TECHNICAL NOTE

2021s1118
Hydraulic Modelling at Fole Dairy
C.B. Collier Limited
May 2022
Alice Blanchard BSc, PgCert, MCIWEM
C.WEM
Daniel Bloomfield BSc
Supplementary information for Fole Dairy

1.2 LLFA response

Figure 1: Model nodes upstream of site

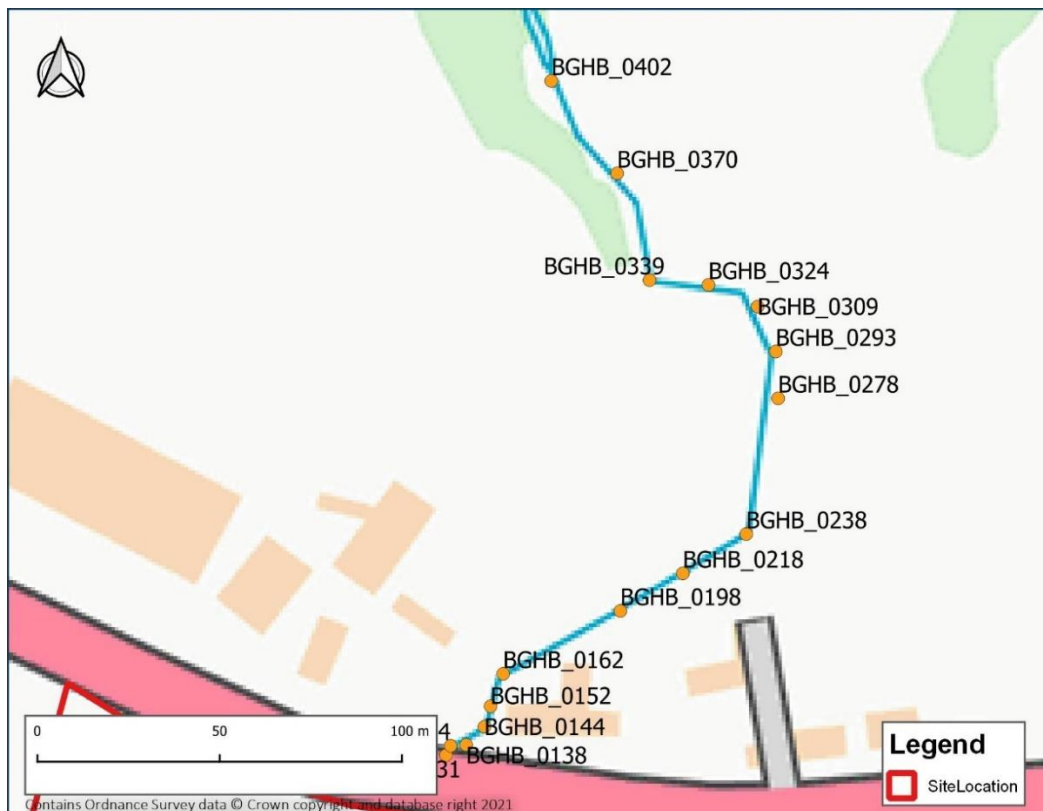
1. In relation to the impacts US of the site, we need a few extra details here given that there has been recorded instances of flooding in relation to the brook. Please could you provide:

Cross section and peak levels along with comparable ground levels upstream of the Uttoxeter road culvert in the baseline and CC scenario to quantify the changes here.

Table 1 shows the peak water levels during the 100-year plus 31% climate change event for the baseline and post-development scenarios. Modelled bank top levels for cross sections upstream of the site are included within Table 1. Figure 1 shows the approximate location of the modelled nodes upstream of the site. Figure 2 displays a long section profile of peak water levels upstream of the site during the 100-year plus 31% climate change event for the baseline and post-development scenarios.

Figure 3: Baseline 100-year plus 31% climate change hazard to people classification

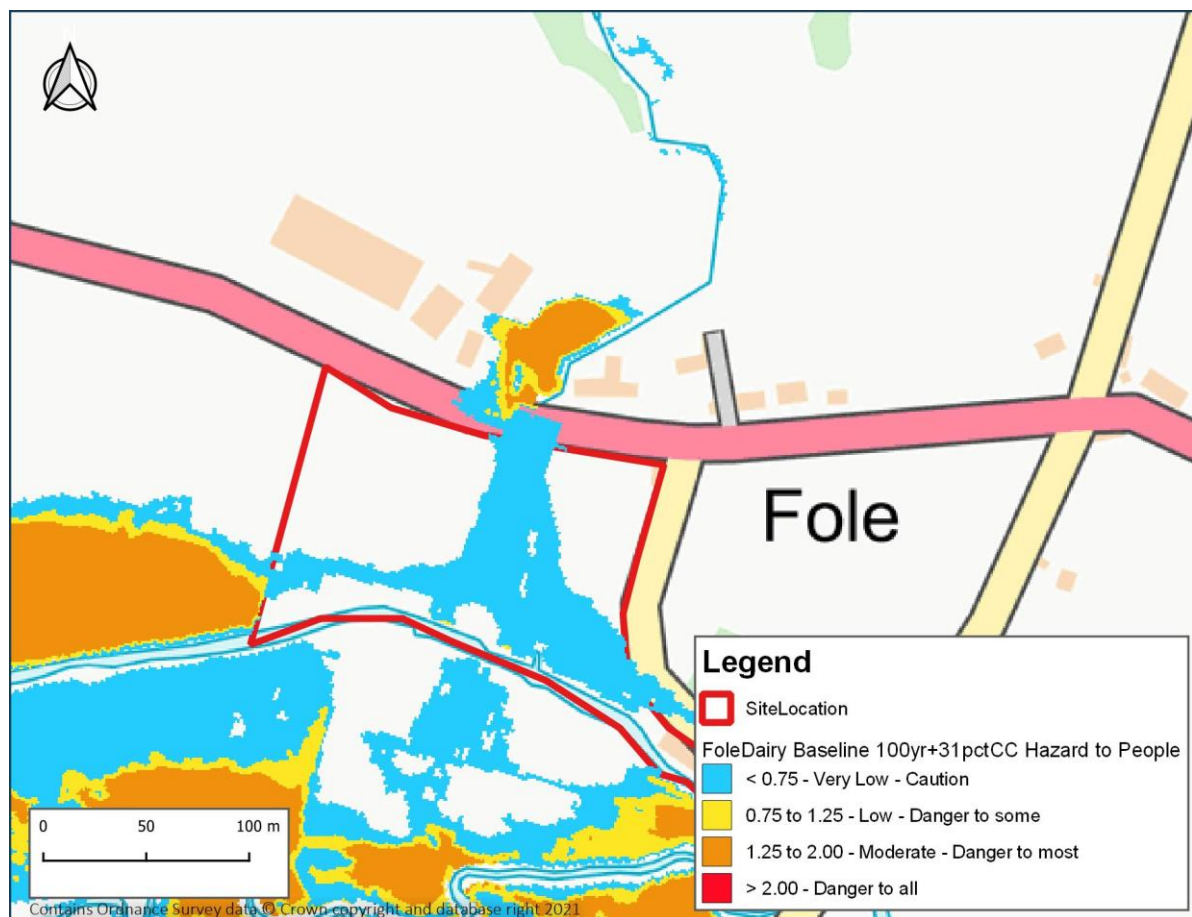
A baseline and post dev hazard rating for the CC event.

Please refer to Figure3-6 of the hydraulic modelling report for the hazard to people classification for the post-development 100-year plus 31% climate change scenario. Figure 3 below shows the hazard to people classification for the baseline 100-year plus climate change scenario.
